ADDENDUM NO. 4

**Armstrong Field
815 Jefferson Street
Three Rivers, MI 49093**

ARMSTRONG FIELD

ADDENDUM 004

OPTIONAL SPREAD FOUNDATION

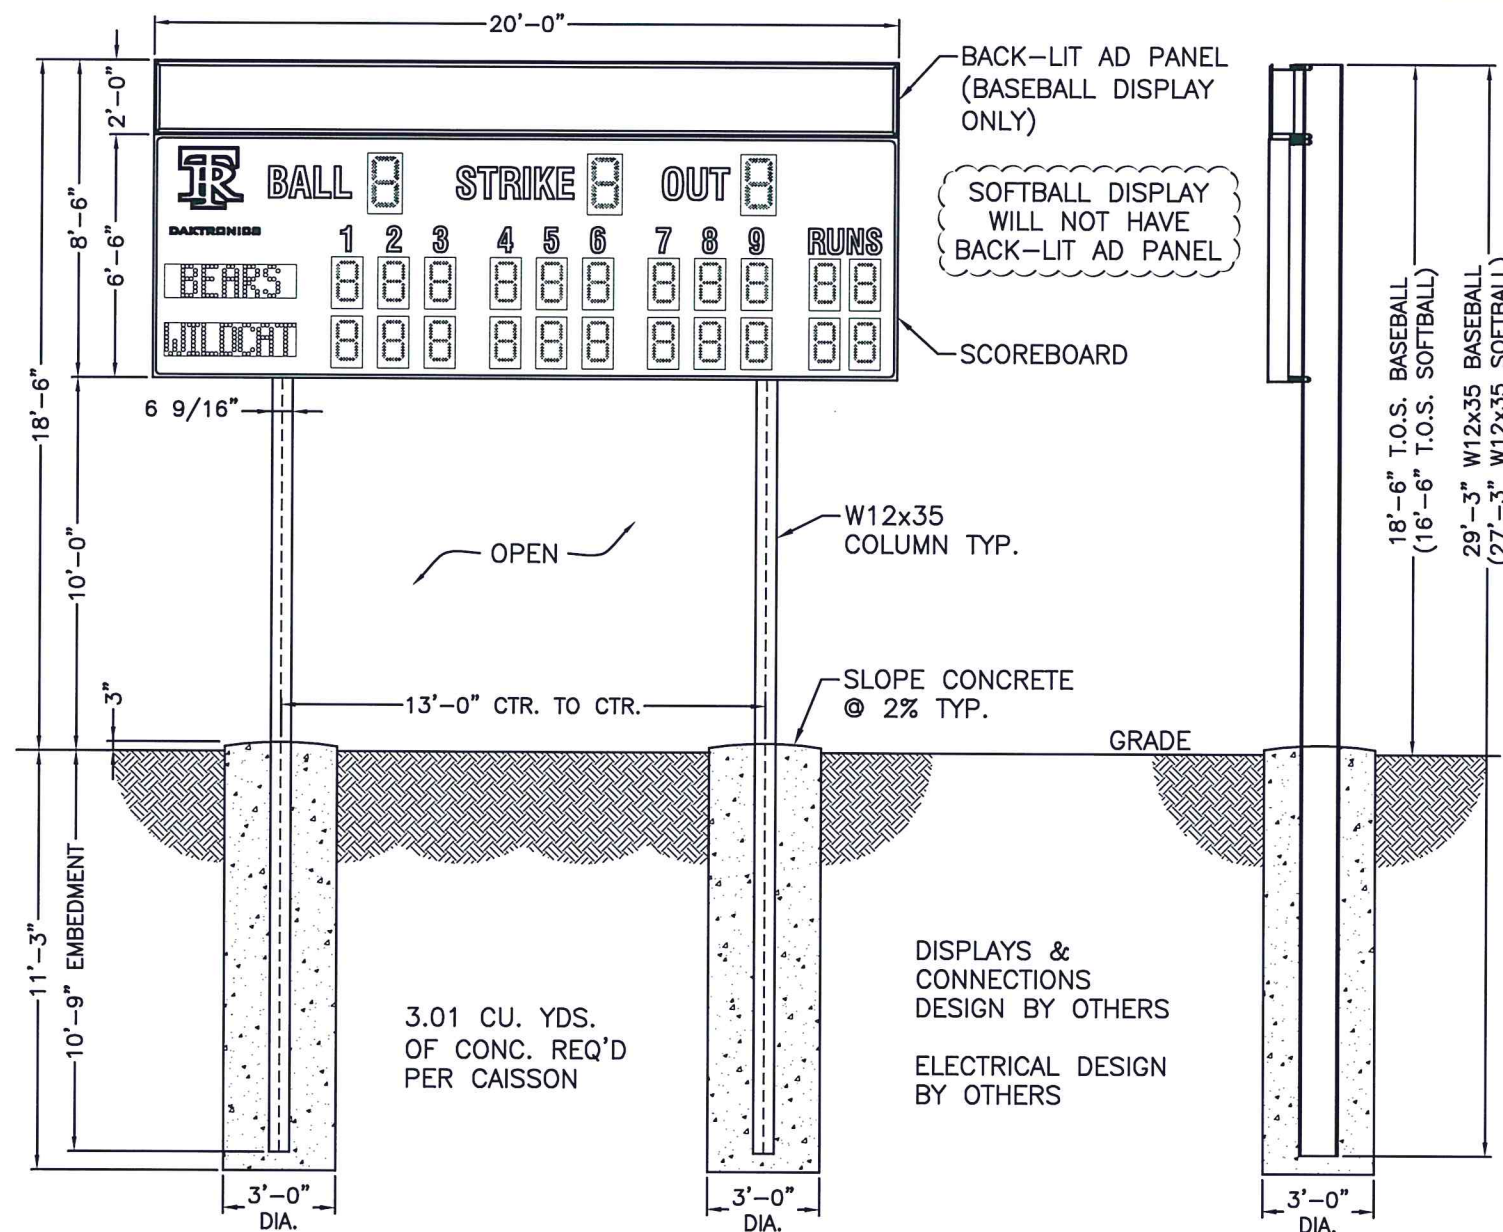
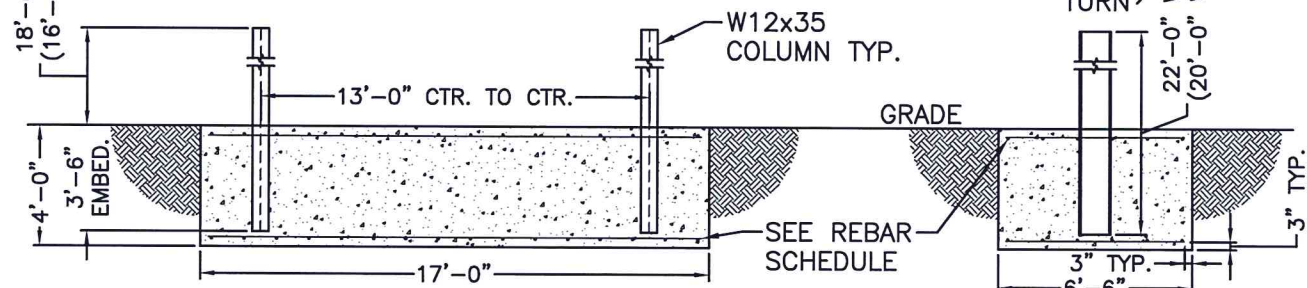
ITEM NO. 13 SHEET B1191806R – DAKTRONICS SCOREBOARD STRUCTURAL DRAWING
(REISSUED)

Sheet revised to include optional spread footing for baseball scoreboard structure.
